Response to MEMO: 12/21/21

Re: Vineyard Wind Maintenance Building (DRI 81-M3)

3/4/22 MVC follow-ups in red 3/4/2022

3/7/22 DRI 81-M3 follow-up responses below in blue 3/14/2022

Attached please find a draft ‘Building Section Detail’ prepared by Foth dated March 4, 2022 to support visualization.

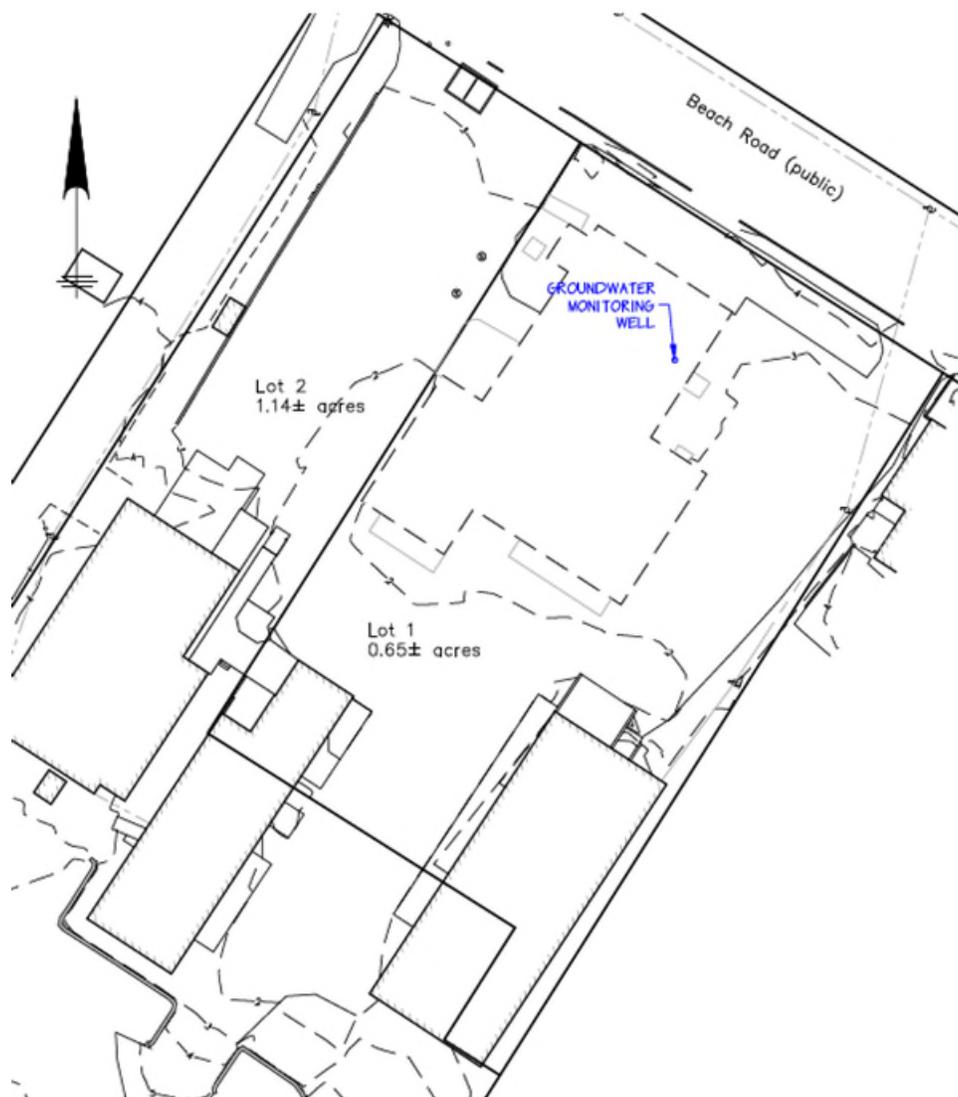
***MVC Question:*** Will the lower level be open on more than one side? A diagram would be helpful.

***Project Response:*** The lower parking level will be fully open on the North, South, and West sides. The East side is partially open towards Beach Road. Please note proposed plantings screen supporting building concrete retaining walls, columns, and pilings.
